## Fresenius Medical Care North America Service Bulletin

Equipment: All 2008 Series Hemodialysis Machines  
 Bulletin: 16-FRS-002 Rev A  
 Subject: New 6.3 Amp Power Supply Fuse

**Figure 1**

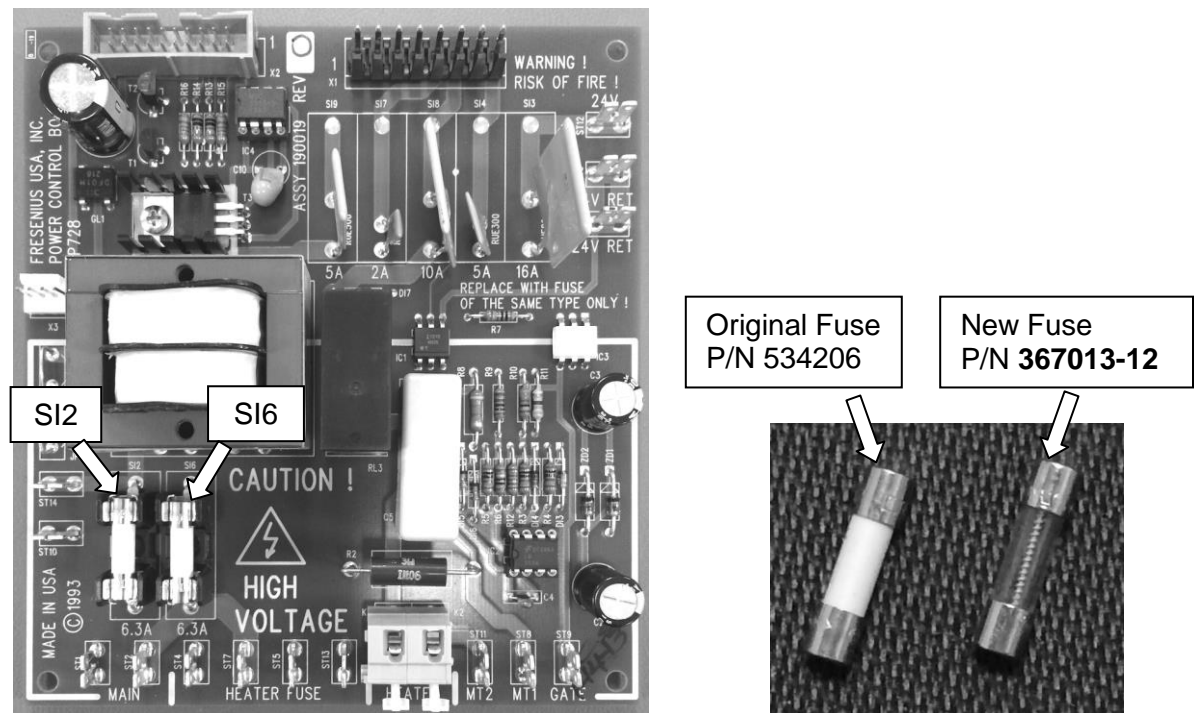
An updated version of the 6.3 Amp fuse used in positions SI2 and SI6 on the Power Control board has been created. Unlike the original fuse, which has a white body, the new fuse has a clear body. See Figure 1 for the fuse locations, the difference in appearance and the part number for the new fuse.
